Additional documents Planning Committee

Wednesday 4 October 2023 6pm

PC2310-4 JACKSON STREET, NO. 20 (LOT 1), NORTH FREMANTLE – ADDITIONS AND ALTERATIONS TO EXISTING SINGLE HOUSE – (JD DA0199/23)

1 - Amended Development Plans

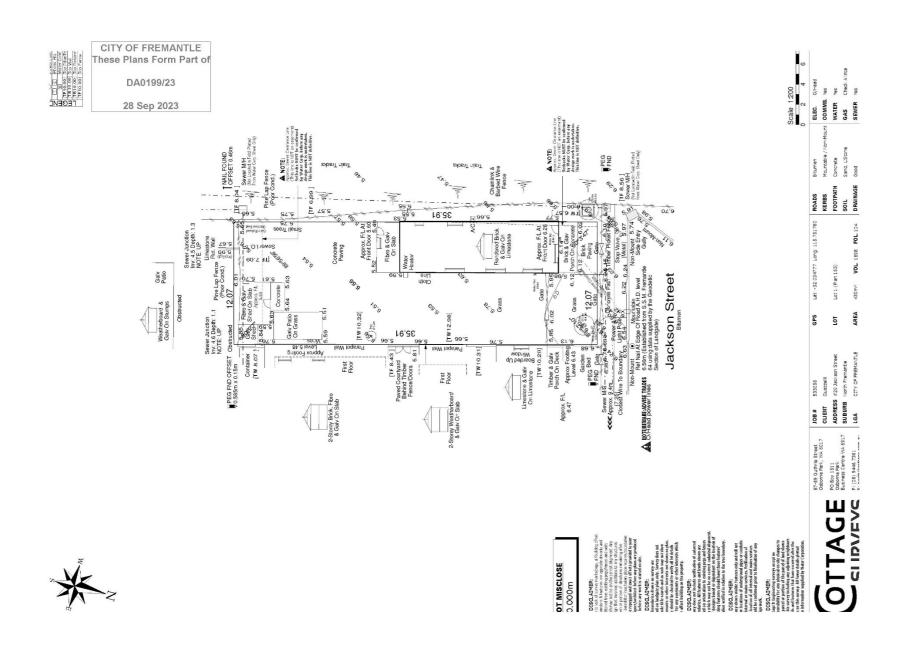
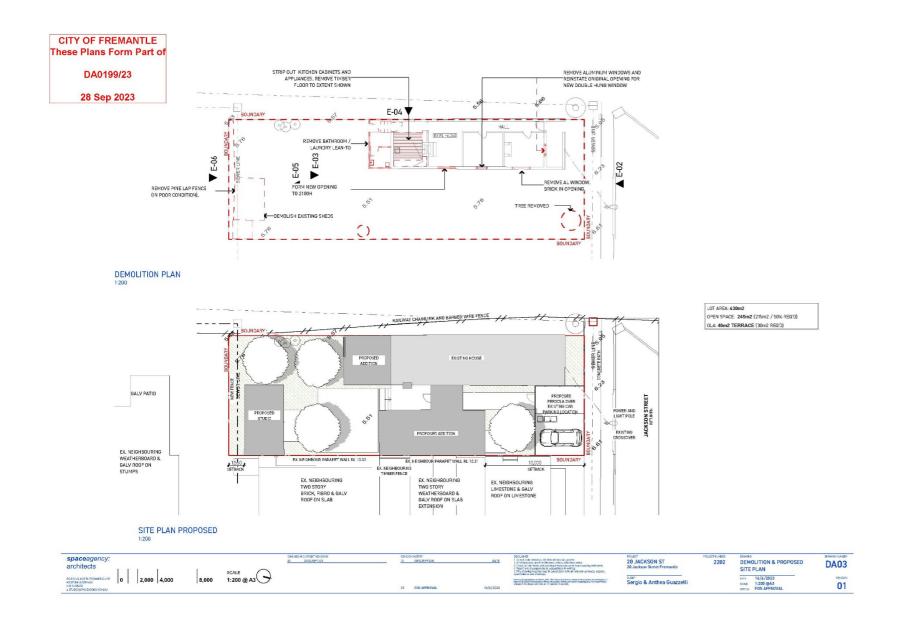
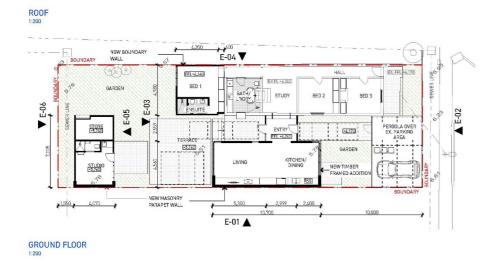
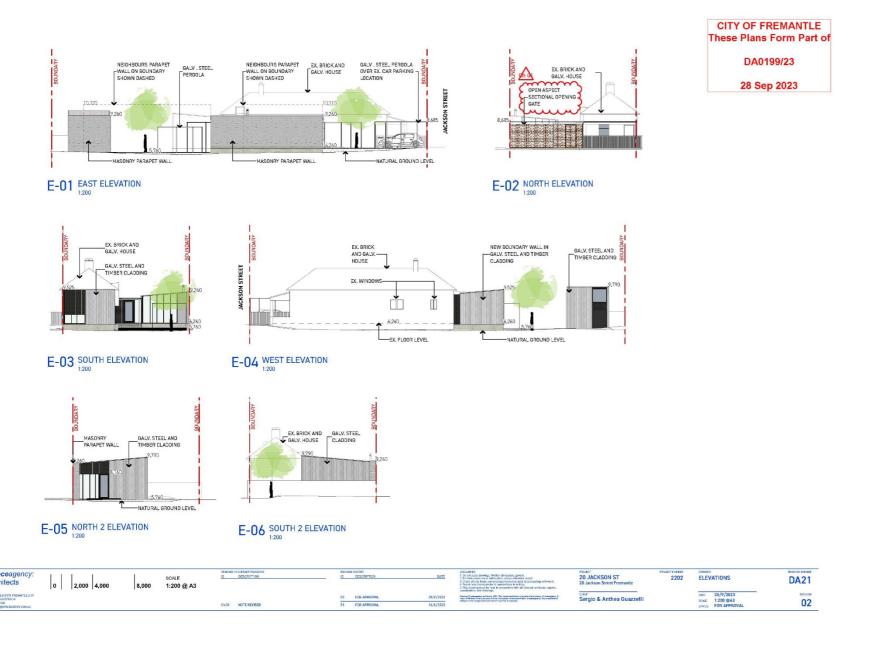
- 1. The proposal is inconsistent with the City of Fremantle's Local Planning Policy 3.6 Heritage Areas as the ancillary structure will detract from the heritage significance of the place due to its proposed location on the front boundary in front of the heritage listed dwelling.
- 2. The proposal is inconsistent with the City of Fremantle's Local Planning Policy 2.9 Residential Streetscape Policy and the Residential Design Codes by reason of the vehicular access driveway being located less than 0.5m from a side boundary and street pole.
- 3.—The proposed 'tilt panel door' presents a risk to users of the footpath due to it's potential to extend into the footpath area upon opening/closing.

The applicant submitted amended plans on 28 September 2023 after the finalisation of the agenda. Any reference to a 'tilt panel garage door' has been removed and has been replaced by a 'sectional opening gate' with the same visual appearance which will not open out over the road reserve. This reason for refusal is no longer relevant, however no other changes have been proposed in the amended plans.

- 3. The pedestrian access and / or vehicle gate, as indicated on the approved plans, shall swing into the subject site only when open or closed and shall not impede the adjoining road reservation of the subject site.

- 4. Prior to the lodgement of a Building Permit application for the development hereby approved, the vehicle gate located on the pergola structure hereby approved shall be a minimum of 50% visually permeable.

- 5. The east side aspect of the pergola structure hereby approved shall consist of wire infill only and shall be a minimum of 85% visually permeable.
- 6. Prior to occupation/ use of the development hereby approved, the boundary wall located on the east side boundary shall be of a clean finish in any of the following materials:
